Figure 7

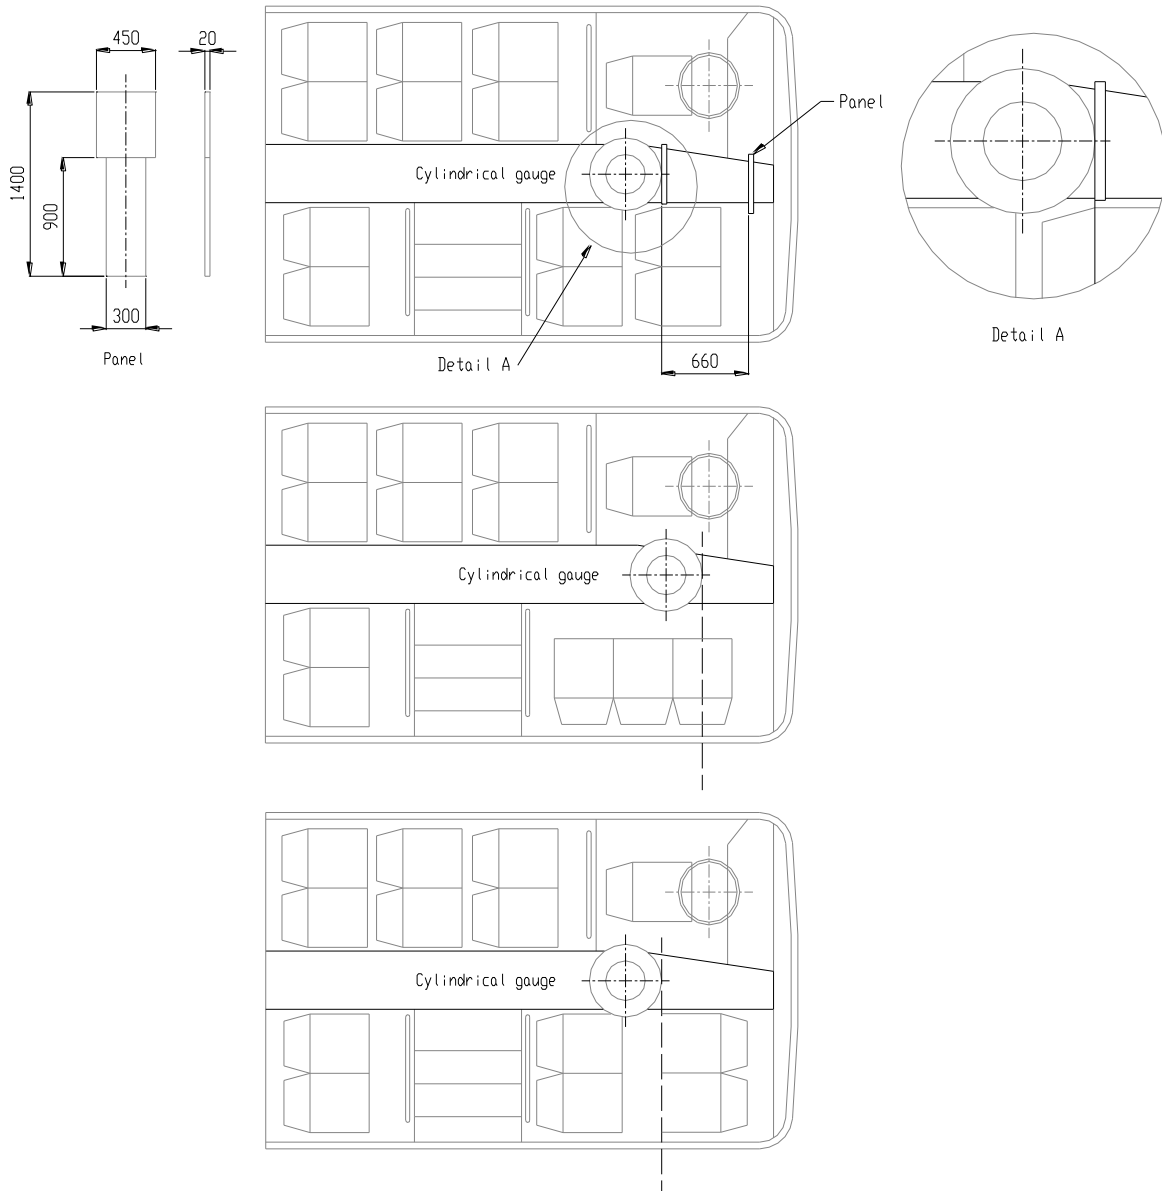
None of the above conditions are applicable to the driver's compartment. The first is the most suited but in most vehicles it is impossible to move the panel forward by 660 mm as the fascia in front of the driver is usually curved so that the controls are within the driver's reach. The proposal that the gangway test gauge is moved to coincide with the driver's seat back (as for paragraph 7.6.1.9.3. describing how a driver's door can be used as an exit for passengers) and then the panel is moved forward to the foremost point of the driver's seat cushion. This is to ensure that the driver has sufficient free height and width when accessing or leaving his seat.

Figure 27

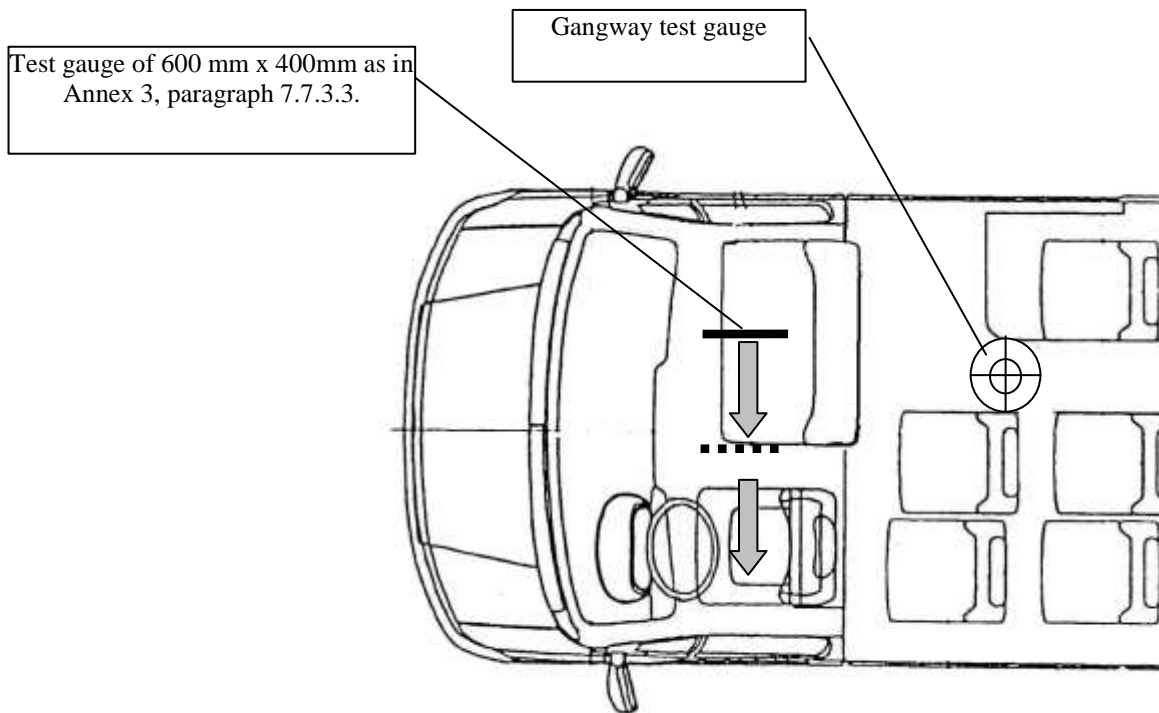
It is clearer if paragraph 7.6.1.7.2. only deals with the driver's seat and seats alongside which do not have a passageway to the passenger's compartment and to put the requirements for the five additional seats in a new paragraph 7.6.1.7.5.
